Re: New York Methodist Hospital
Center for Community Health
505-525 6th Street (Block 1084,
Lots 25, 26, 28, 39-44, 46, 48,
50-59, 164, 1001, and 1002)
BSA Cal. No. 289-13-BZ

We are submitting this letter in connection with the application by New York Methodist Hospital ("NYM" or the "Hospital") for a variance to facilitate the development of a new ambulatory care facility (the "Center") Hospital's main campus in Brooklyn. This letter and the attached materials provide responses to questions asked by the Board at the February 11, 2014, public hearing on the application, as set forth below.

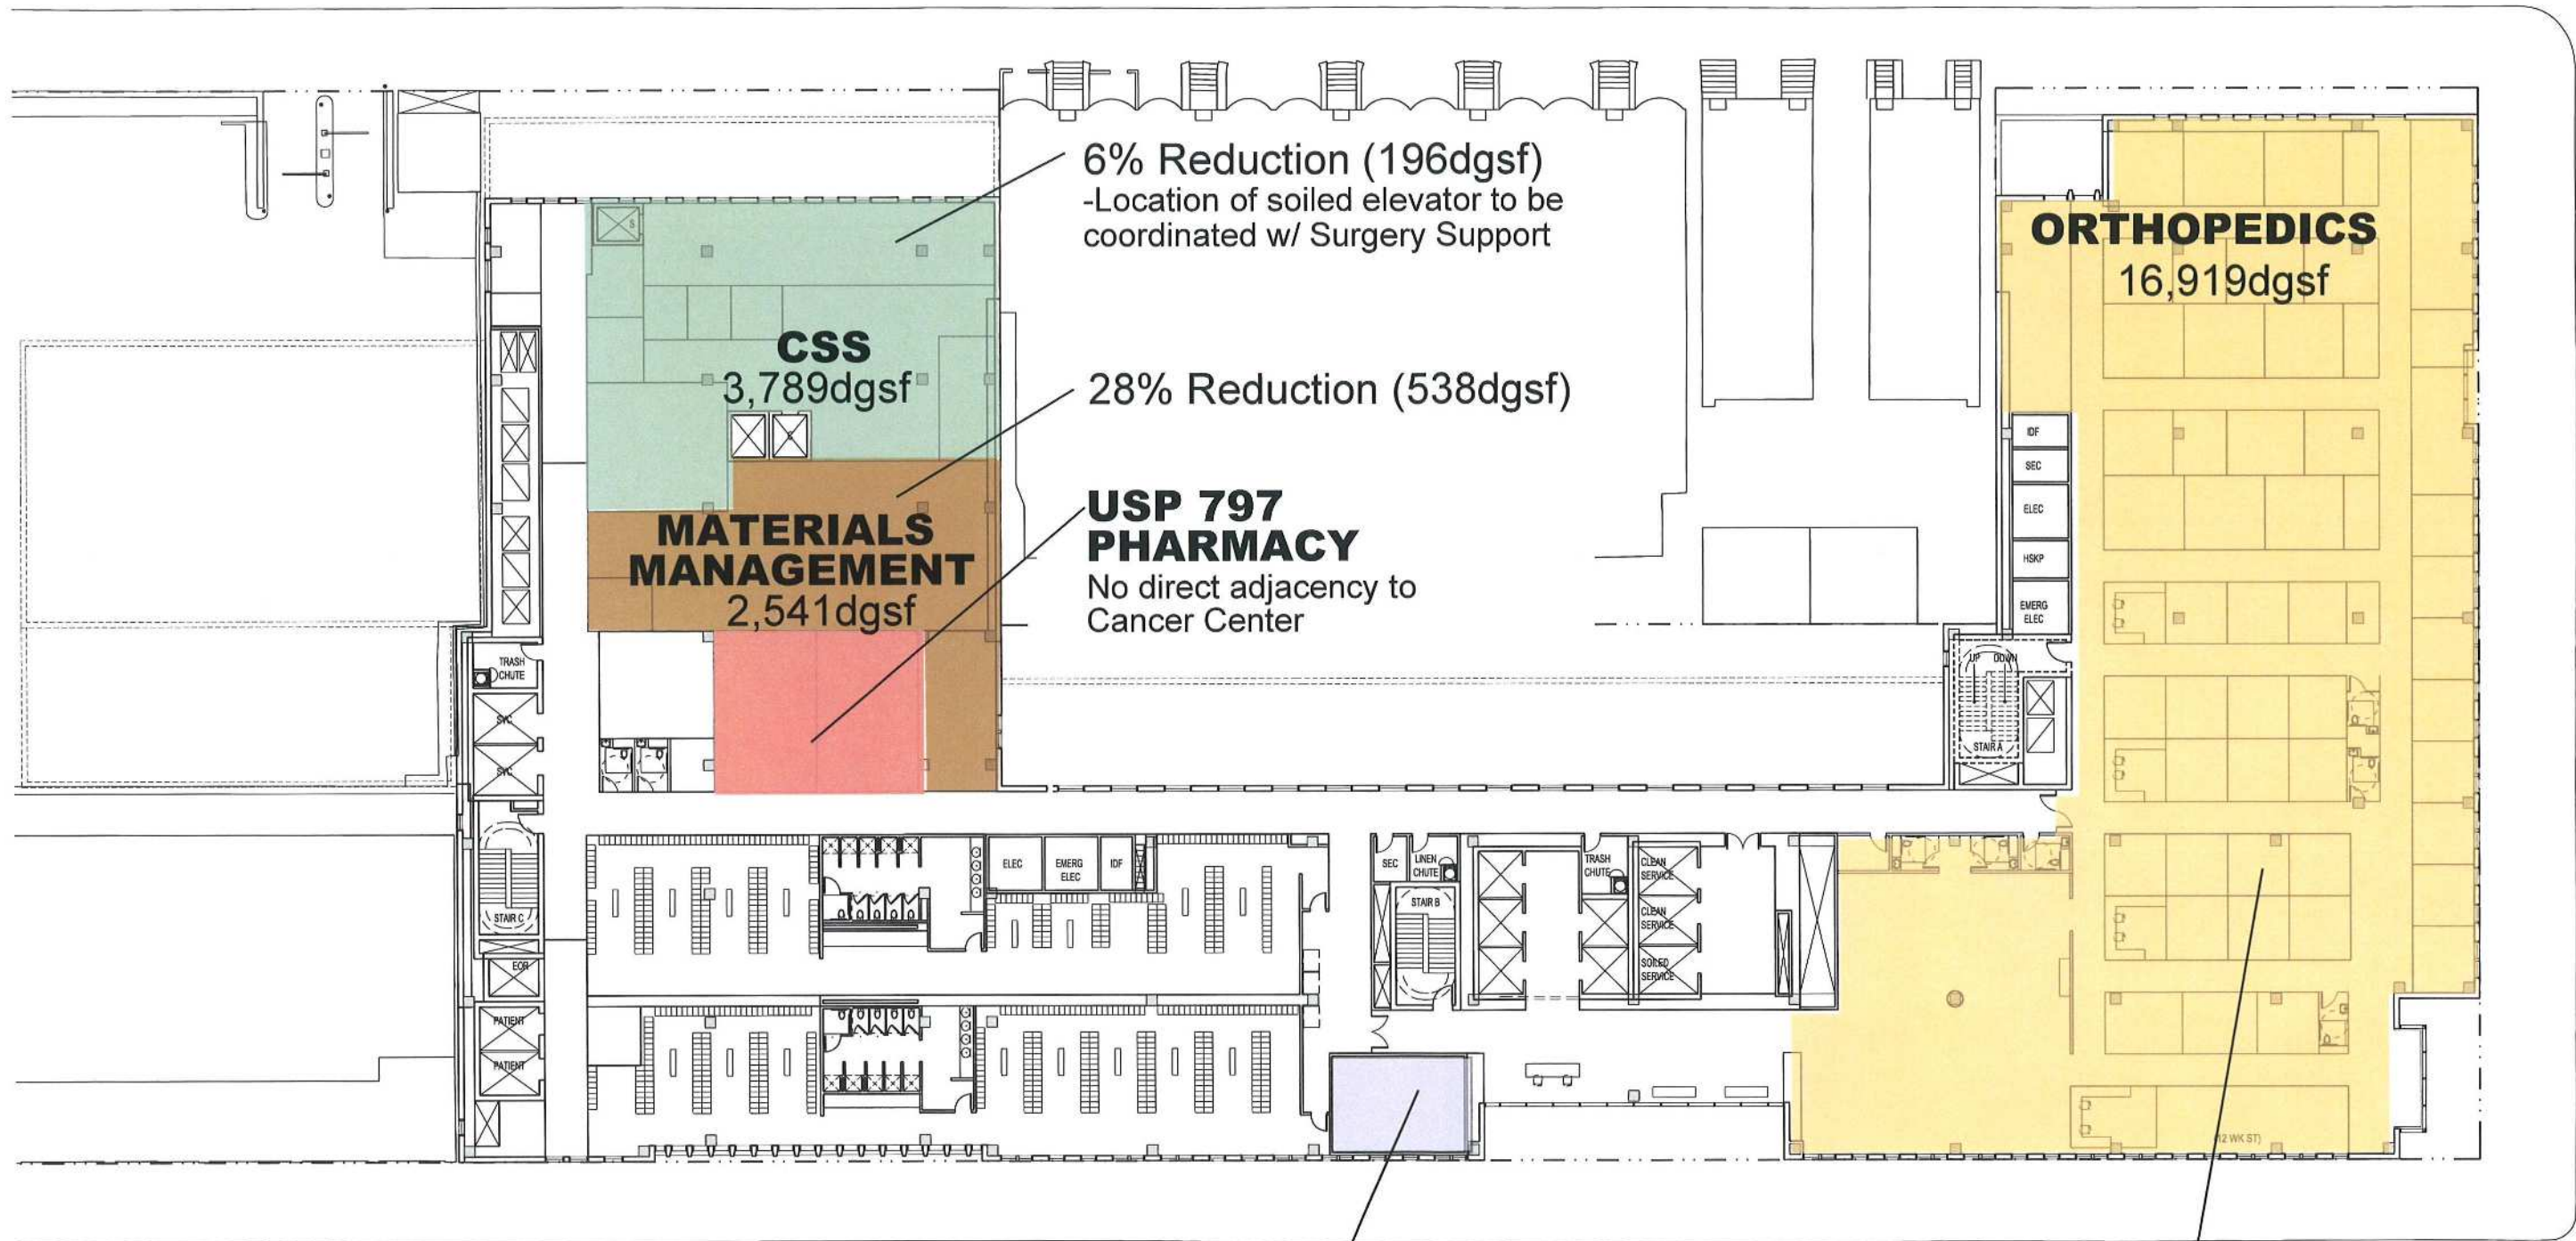
- The location of CSS on the 4th floor with an increased setback from 5th Street would require that the building's soiled elevator and flanking support spaces be moved southward to remain within the building envelope. (See Lesser Variance Study, 4th Floor Plan Diagram) In order to accommodate the relocation of the elevator shaft and support spaces on the 3rd floor while maintaining sterile connections, the building's surgical suite must be reduced in size. This would require the displacement of support space or a reduction in the size of one or more ORs, with a resulting reduction in services to the community. (See Lesser Variance Study, 3rd Floor Plan Diagram)

Surgery and support spaces impacted due to required shifting to the south of soiled elevator and support spaces

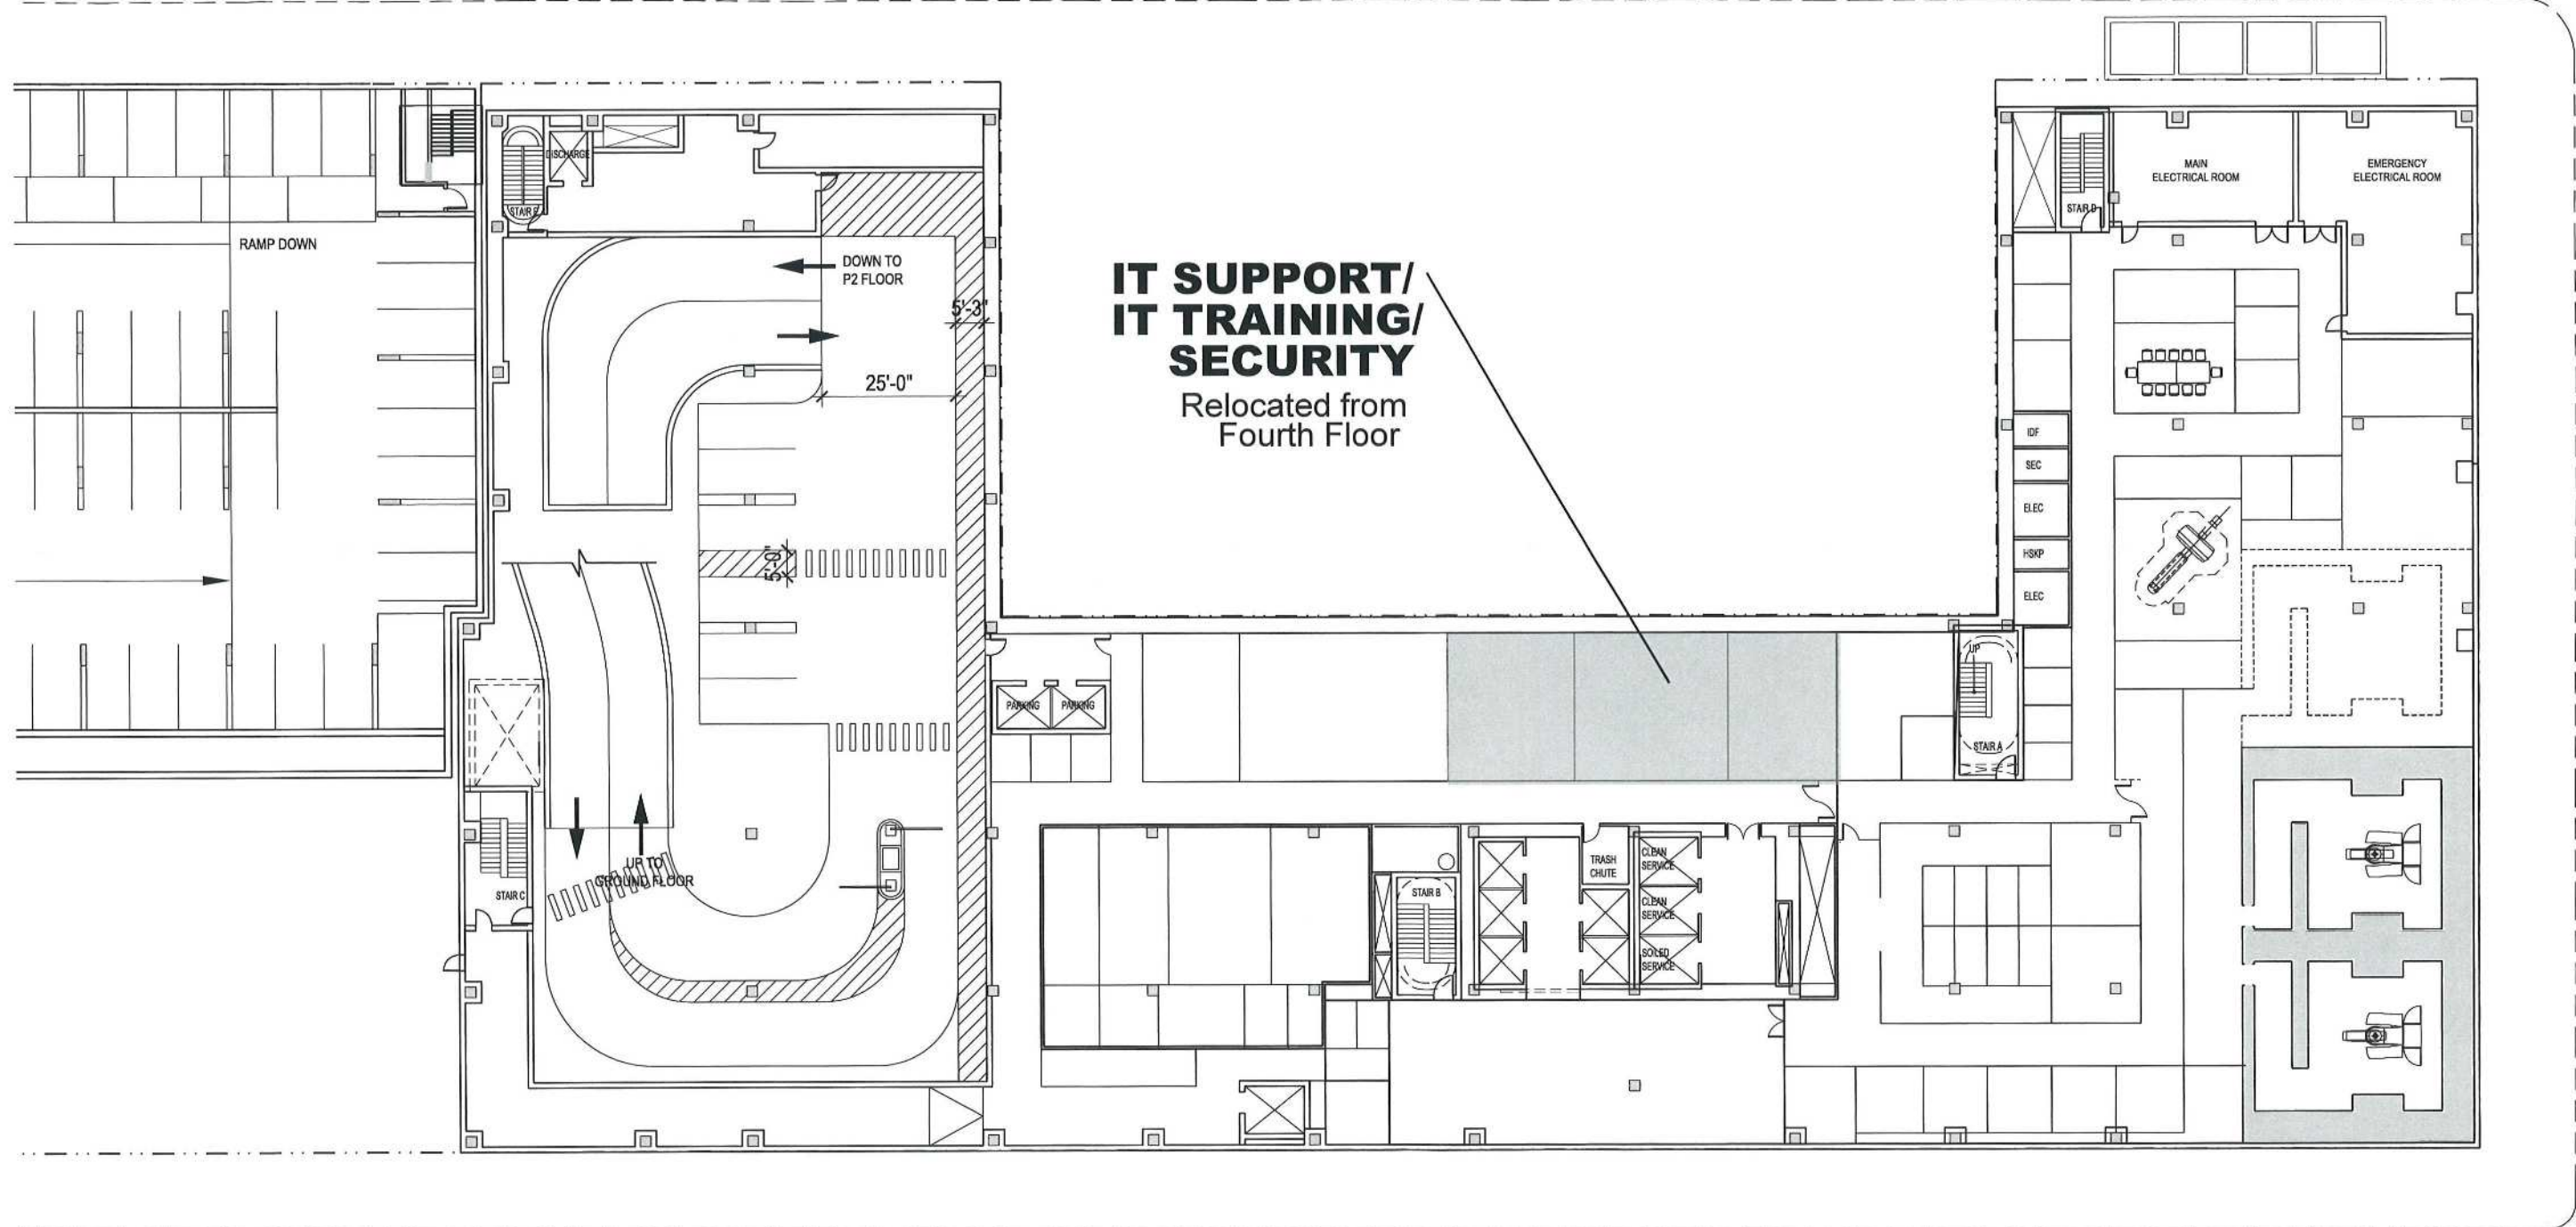
- Many healthcare program areas would be relocated or reconfigured, with the resulting elimination of efficient adjacencies. In the Lesser Variance Study, the Women's Center on the 7th Floor can be accommodated only by splitting the department into two spaces, one on each side of the building's circulation core, resulting in a bifurcation of services, increased travel times, and less efficient circulation paths for patients and staff. Rapid Response Lab and USP 797 Pharmacy are relocated from the 6th floor to the 4th floor, two floors away from the 6th floor Institute for Cancer Care that such facilities predominately serve. Further, mechanical and electrical equipment spaces currently located in the setback areas would be displaced, requiring a reconfiguration of program areas to accommodate them in new locations.

15% Reduction (2,343dgsf)
-Department split across circulation
core creating less efficiency
